Bair Ranch Area - I-70 MM 128 Elevation ≈ 7,000'

CDOT Region #3

Summary Observations

Visitor Information, Vending Machines, Picnic Tables

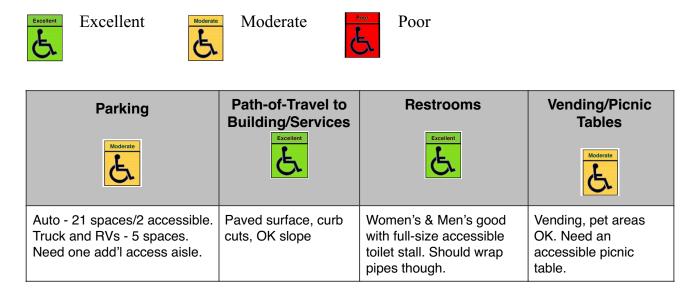
The information displays and vending machines are accessible. Suggest replacing one of the picnic tables with an accessible table which allows a person using a wheelchair to use the table top.
